JACOBS ENGINEERING GROUP INC.
VENDOR/CONTRACTOR/SUBCONTRACTOR DOCUMENT STATUS
Proj. No.: 63KA065 P.O.#: A2VV-4-0707-131 - Cotter Brothers Cor
Route Sheet No.: 0148 Description: Low Pressure Liquid Chromatograph
JE Vend. Doc. No.: 1337 - 01 Vend. Doc. No.: CBC M01
STATUS (Check One Block Only)
☐ APPROVED
☐ APPROVED AS NOTED
☐ REVISE - RESUBMIT
☐ DISAPPROVED - RESUBMIT
☐ NOT REQUIRED FOR REVIEW
☐ CERTIFIED RECORD COPY
JE review is for the limited purpose of checking for conformance with information given and the design intent expressed in the Contract Documents. The review does not extend to the Vendor/Contractor/Subcontractor of the duty to meet the requirements of the Contract Documents or to guarantee the accuracy and completeness of this information. Contractor/Subcontractor is the responsible of the Vendor
BY: DATE: 11/28/06

AMGEN MANUFACTURING LTD
JUNCOS, PUERTO RICO

Title: AML 7X EXPANSION - DEAE SKID
Chromatography System 52004-CS-01
PLAN & ELEVATION VIEWS

Drawn by	C. UMANITA	Date	11/20/06
Checked by	TED ZARUBAIKO	Date	11/22/06
Dwg. Type	MECHANICAL	Scale	1.5"=1'-0"
Drawing No. AMG48	Sheet No. M01	Revision A

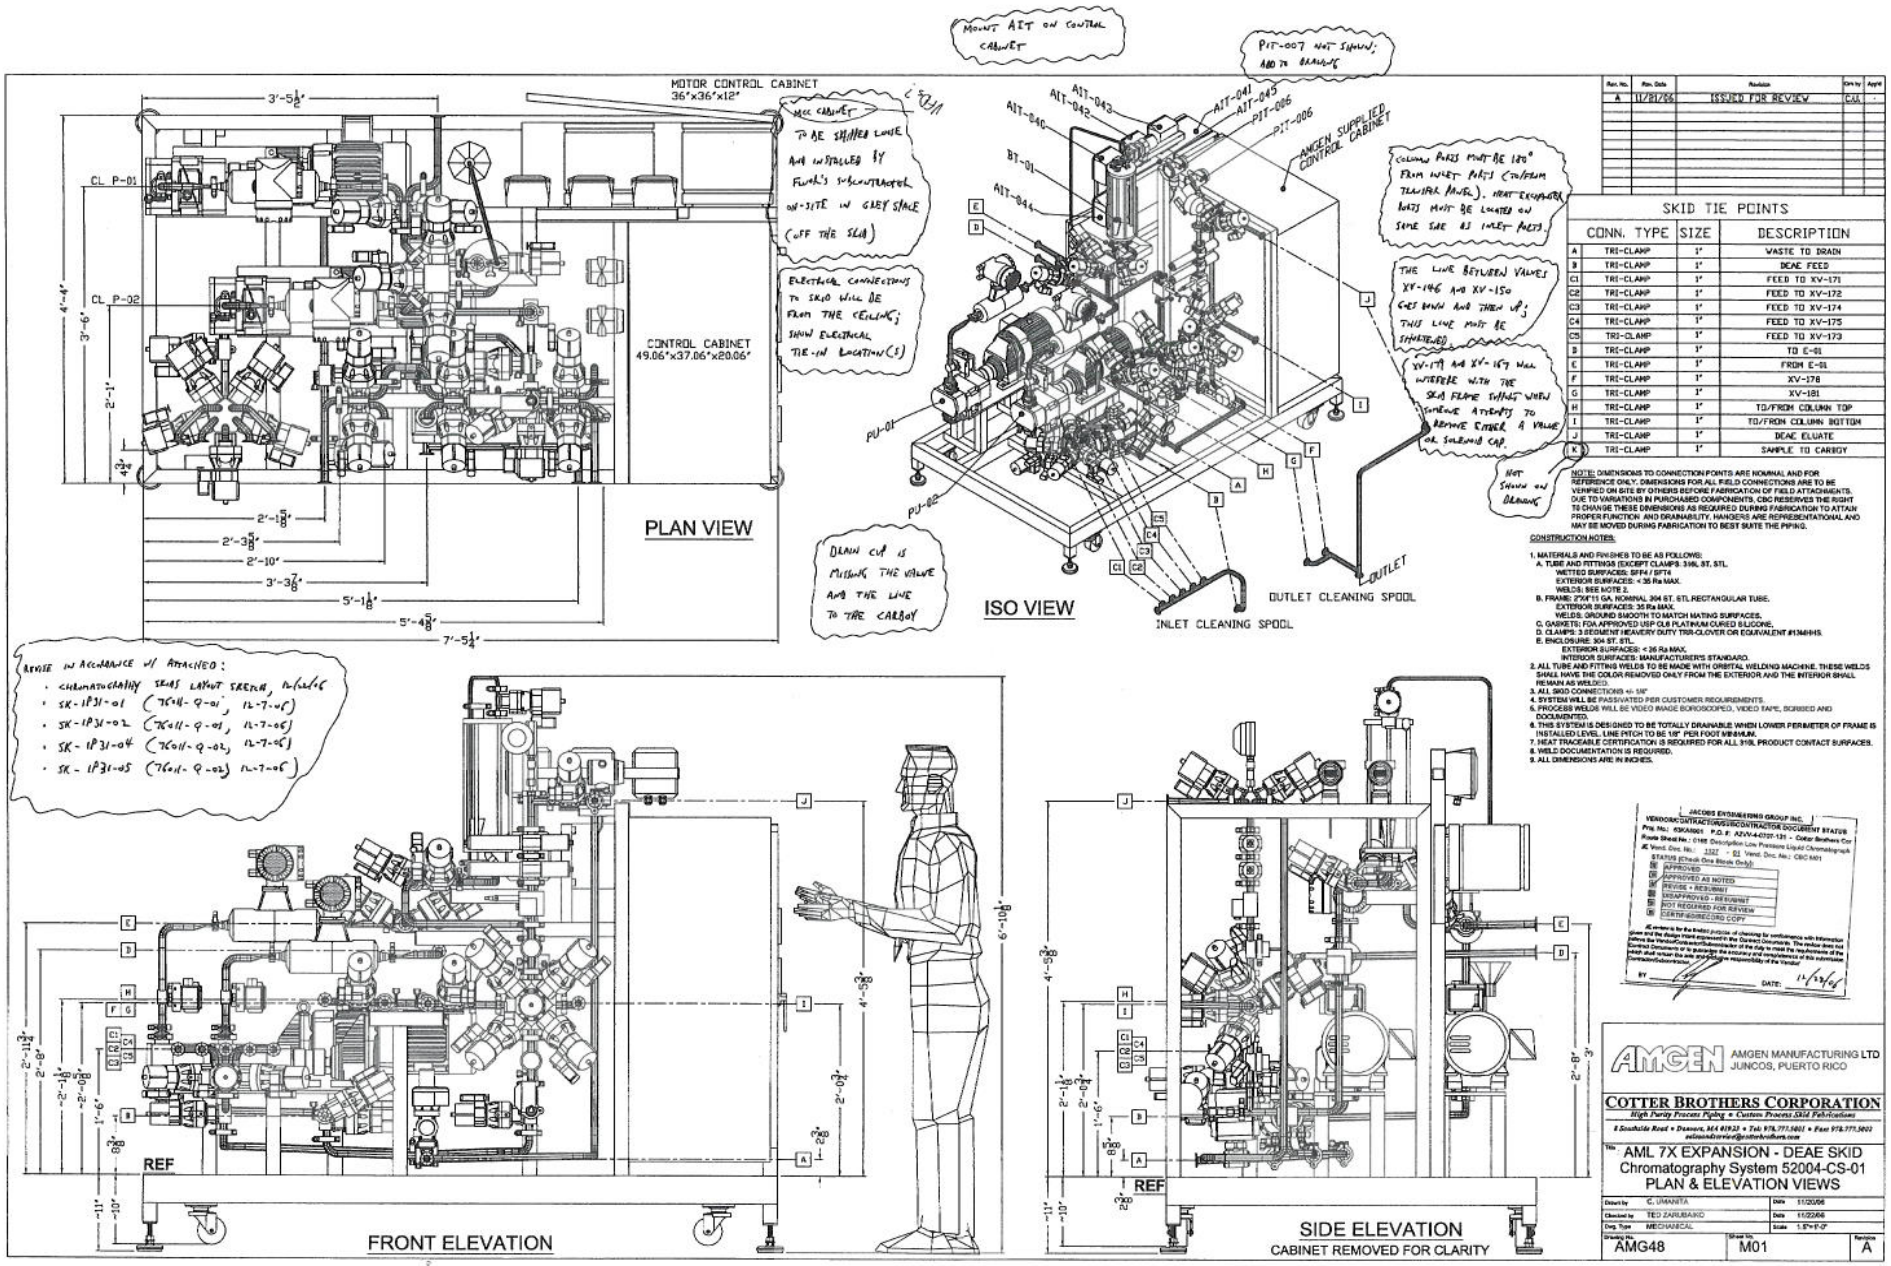
COLUMN PORTS MUST BE 180° FROM INLET PORTS (TO/FROM TRANSFER PANEL). HEAT EXCHANGER PORTS MUST BE LOCATED ON SAME SIDE AS INLET PORTS.

THE LINE BETWEEN VALVES XV-146 AND XV-150 GOES DOWN AND THEN UP; THIS LINE MUST BE STRAIGHTENED

XV-179 AND XV-167 WILL INTERFERE WITH THE SKID FRAME SUPPORT WHEN SOMEONE ATTEMPTS TO REMOVE EITHER A VALVE OR SOLENOID CAP.
